Groundwater Application Review Summary Form

Application # G- 18261 (RE-REVIEW)

TO: Water Rights Section Date 11/03/2017
 FROM: Groundwater Section Dennis Orłowski
Reviewer's Name
 SUBJECT: Application G- 18261 Supersedes review of 05/31/2016
Date of Review(s)

A. GENERAL INFORMATION: Applicant's Name: Jay Thompson County: Marion

Water-Level Trends in Nearby Wells

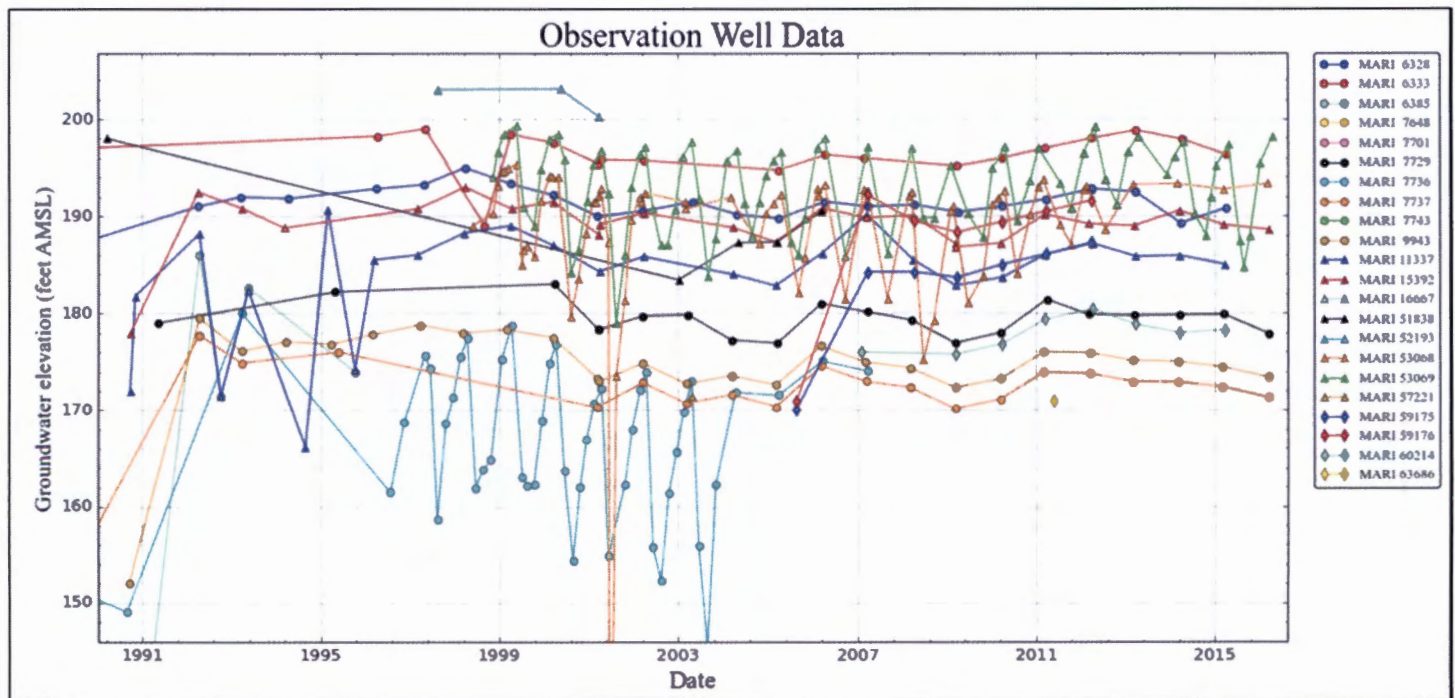
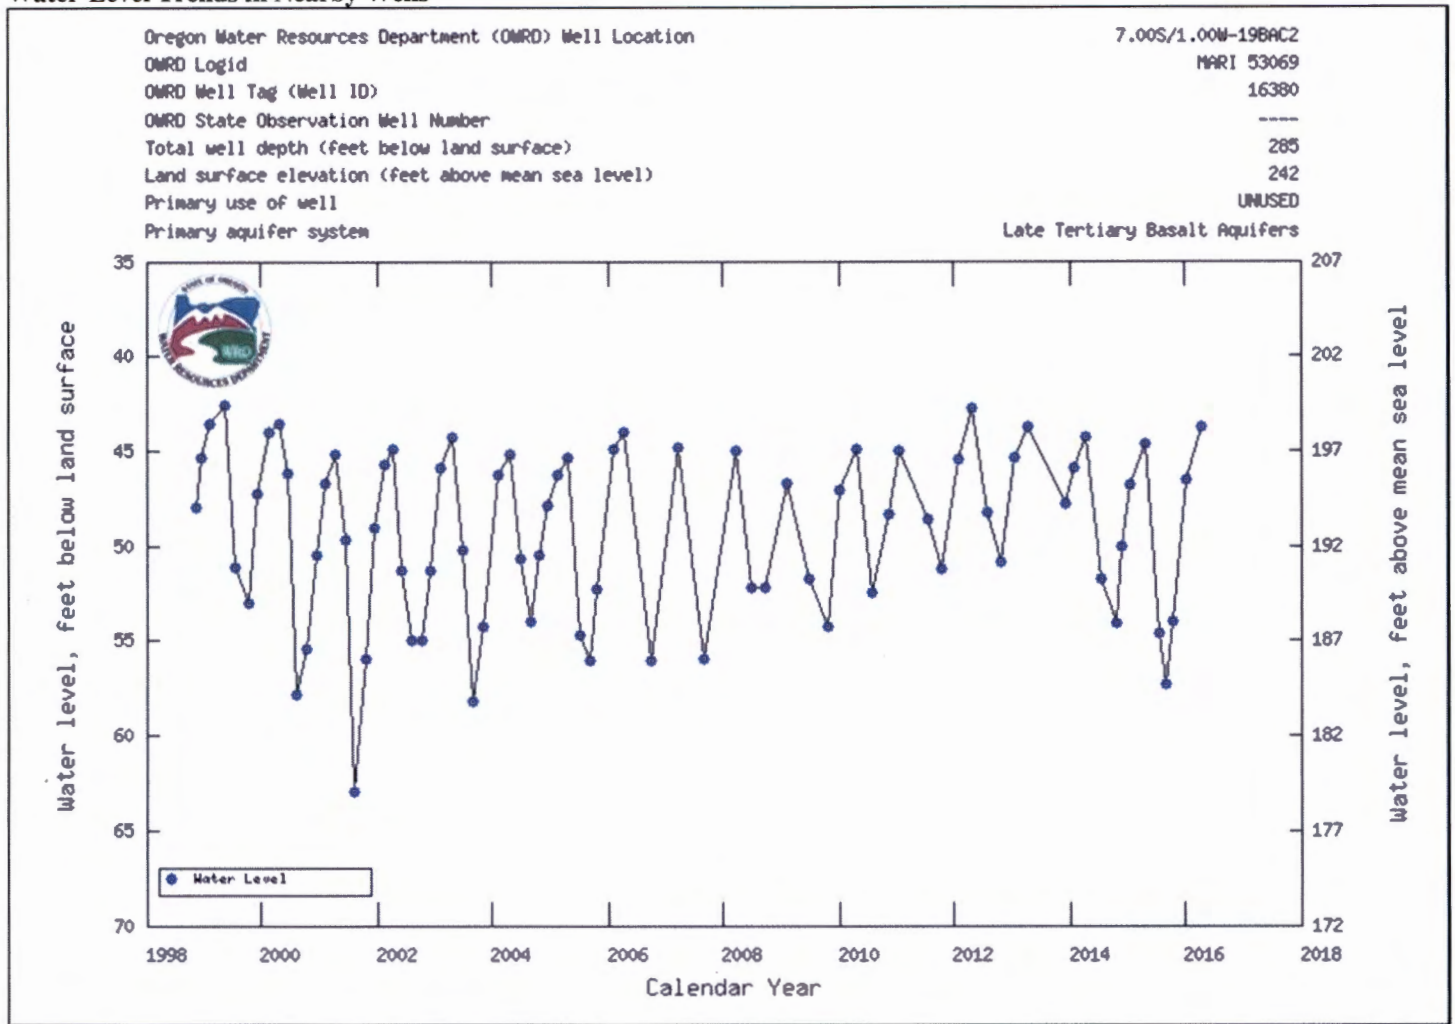
In general, water levels in nearby deeper basalt irrigation wells have been stable over the last twenty years. Limited data (primarily from MARI 53069, MARI 53068, and MARI 736) indicate that seasonal fluctuations are on the order of 10-20 feet. Many basalt irrigation rights have been issued in the area over the last 30 years but the extent to which all of these rights are exercised in any given year is unknown. However, stable water levels suggest some additional capacity for development. Well logs for nearby basalt wells show a median yield of 250 gpm and a range from 10-850 gpm. The well log for the proposed POA, MARI 66870 reports a yield of 100 gpm (air test). Groundwater may be available in the amount requested, although multiple wells may be required to obtain the amount.
